SUBJECT: PERRY NUCLEAR POWER PLANT, UNIT 1– FLOOD HAZARD MITIGATION STRATEGIES ASSESSMENT (CAC NO. MF7960; EPID L-2016-JLD-0007)

STAFF ASSESSMENT RELATED TO THE
MITIGATION STRATEGIES ASSESSMENT FOR
PERRY NUCLEAR POWER PLANT, UNIT 1
AS A RESULT OF THE REEVALUATED FLOODING HAZARDS REPORT
NEAR-TERM TASK FORCE RECOMMENDATION 2.1- FLOODING
(CAC NO. MF7960; EPID L-2016-JLD-0007)

Figure 3.6.1 Perry Nuclear Power Plant with proposed layout of site modifications. (Source: FENOC Audit –Licensee generated figure, See Section 4) (Source: Public Meeting held June 29, 2017 (ADAMS Accession No ML17193A419))

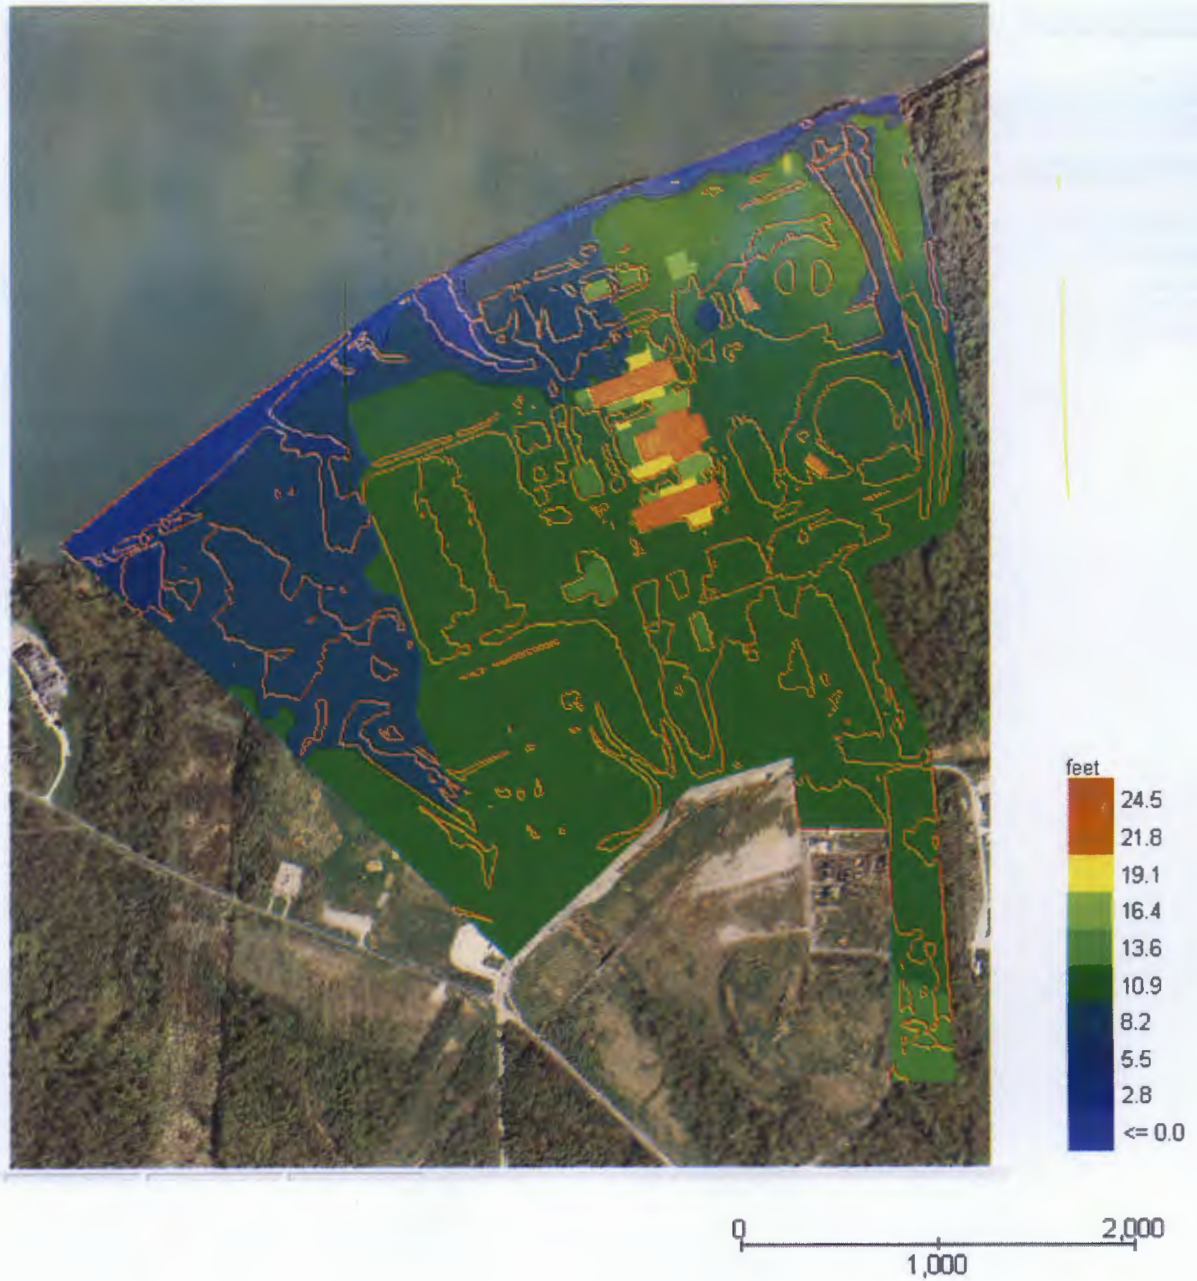
level represents the highest predicted flood WSE at plant doors which either lead into safety-related buildings or into non-safety-related areas which communicate with safety-related buildings. Additional details regarding the audit performed are described in Section 4 of this document. The licensee also indicated that there were five postulated scenarios of LIP temporal-peak-loading under consideration in the analysis; however, the one selected for the final analysis is the end-peak-loaded distribution since it produces more conservative flood levels when compared to other scenarios. The NRC staff's confirmatory analysis of the FLO-2D model indicated that there are locations where the WSEs were higher than the reported maximum WSE value for the LIP flooding. In response to the NRC staff's request during the audit, the licensee stated that other plant structures may experience higher WSEs at doorways, but that these buildings are not important to the implementation of FLEX strategies and do not have the potential to impact the FLEX strategies.

The licensee stated that for the LIP flood causing mechanism, the WSE inundates the Powerblock area and poses challenges for FLEX as a result of flooding of the deployment paths, staging areas, and water levels above critical doors which are important for implementing the FLEX strategies. However, the installation of door flood barriers and alternative deployment paths available will make it possible for the implementation of the FLEX strategies. The licensee used FLO-2D Pro software (FLO-2D, 2013: Build 16.06.16 which incorporates the Storm Water Management Model [SWMM] 5.0.022) to determine the maximum WSEs and flood depths for the LIP event at critical door locations. Figure 3.6.2 presents the FLO-2D confirmatory analysis LIP flooding maximum WSE and inundation area, while Figure 3.6.3 presents the inundation area details resulting from the Minor Stream and LIP with fetch lengths. The licensee stated in its MSA that the fetch lengths are insignificant to the result in wave runup. The NRC staff performed a confirmatory modeling of the LIP flooding mechanism using data obtained from the licensee as part of the audit, the FLO-2D modeling software, and present day guidance and methodologies. The confirmatory modeling was performed to verify the licensee's modeling parameters and consistency of the reported WSEs. Based on its review of information provided by the licensee, the NRC staff confirmed that the results of staff's confirmatory modeling for WSEs are consistent with the values stated in the MSA report, and the supporting information reviewed as part of the audit. Therefore, the NRC staff determined that the reported changes in the simulated LIP flood elevation values (summarized in Table 3.6-1) are inconsequential, and that the updated flood levels provided in the MSA are acceptable for use in the evaluation of FLEX strategies.
